**Re: Umatilla Wanapa Road Water Treatment Facility  
(Wigen Skids w/Toray HFUG-2020AN UF modules)  
City of Umatilla (PWS ID #00914)  
Conditional Approval ([PR#16-2024](#))**

On February 1, 2024, the Oregon Health Authority's Drinking Water Services (DWS) received 100% design plans for the City of Umatilla (PWS ID# 00914) Wanapa Road Water Treatment Facility (Woodard & Curran Project #0233937.02). The design is for a membrane plant initially using two Wigen filtration skids equipped with 30 Toray HFUG-2020AN ultrafiltration membrane modules per skid, rated at a total membrane capacity of 2.02 MGD (1.01 MGD net product per skid) to provide industrial process water.

**At this stage, the plans are granted “Conditional Approval”, which means construction may proceed provided the following conditions are met prior to Final Approval:**

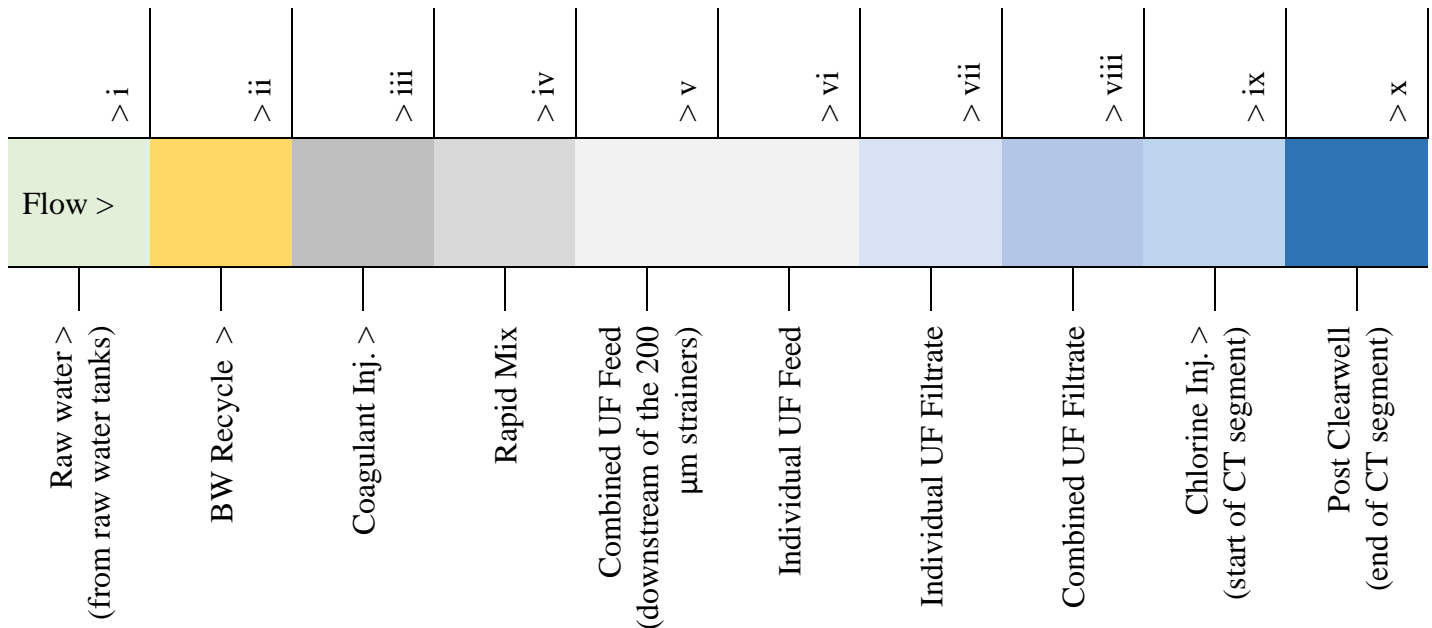
- 3) **Water quality data is verified.** Data provided in the submittal indicated a design using a maximum feed water turbidity of 5.5 NTU with an average turbidity of 4.5, however, it is unclear if this data was representative of the Columbia River source water as the design documentation referenced the Rogue River as shown in the text field below. **Please verify the source of the raw water quality data.**

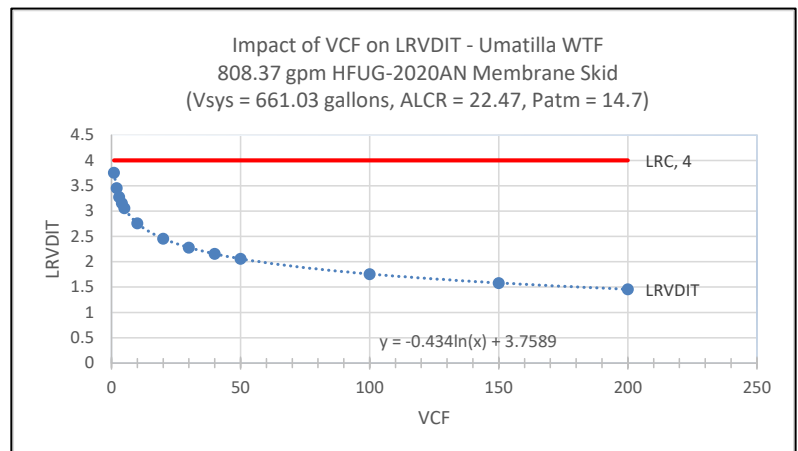
**6) A method for determining the Volumetric Concentration Factor (VCF) is provided for all the skids, taking into account the backwash recycle stream and the backwash recovery skid, which is designed to operate in cross-flow mode.**

Per the submitted documentation, the 12,000-gallon backwash recovery (TK-451) receives backwash wastewater from all the UF skids. The effluent of the backwash recovery tank can either be diverted to a 50,000-gallon backwash waste holding tank (TK-450) for subsequent disposal or be pumped to the feed side of the backwash recovery skid (UF430). The backwash recovery UF skid (UF430) is a copy of the primary UF skids with the additions of backwash recovery inlet, to allow recovered backwash to be fed to the train, and the UF filtrate to strainer valves, that will direct filtrate to the header ahead of the automated strainers. This backwash recovery skid is further differentiated from the primary skids in that it has the ability to deliver filtrate water to the finished water holding tanks via the UF filtrate combined header. This skid is also equipped with a recirculation system to create a crossflow to prevent packing of the solids in the modules (added March 2023 with Addendum 3-1).

**Coagulation:**

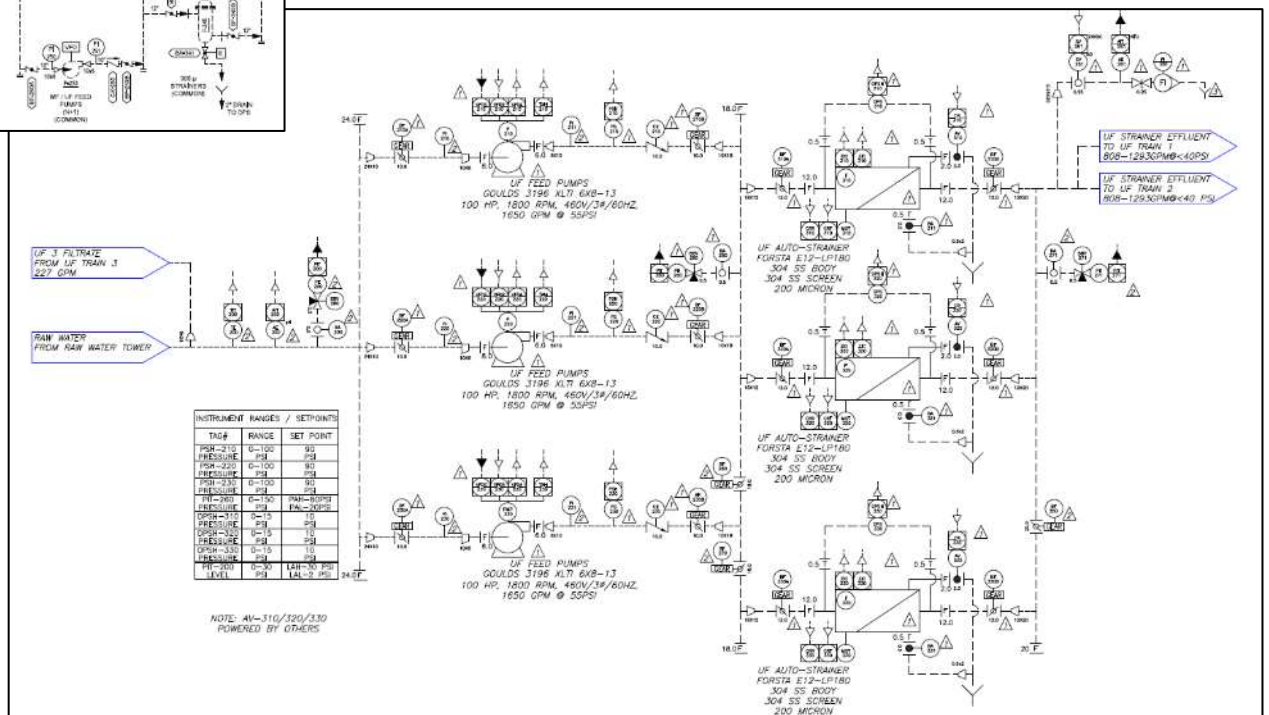
An optional coagulation feed location is identified on the general process diagram in the distribution header between pumps P220 and P230 for future use. Mechanical plans do not show this injection location.

Process Flow Diagram G-3-601

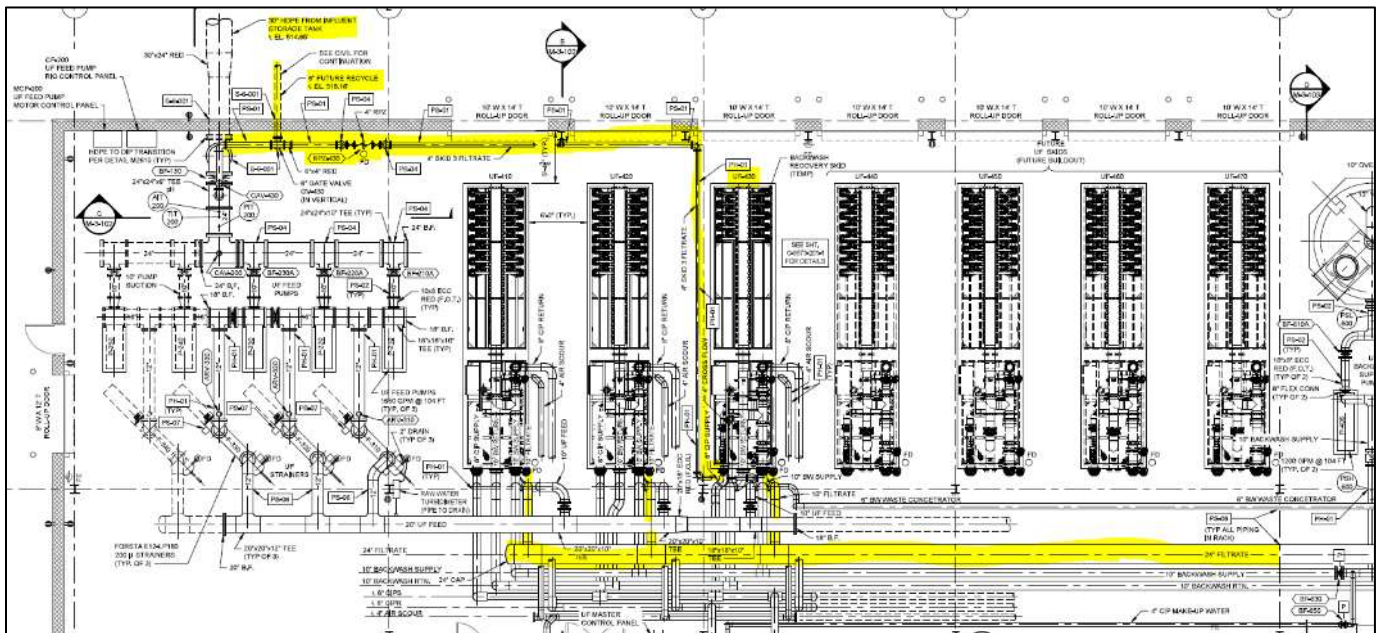
The recycle blend is anticipated to be 4-10% (recycle blended with 90 – 96% of raw water).
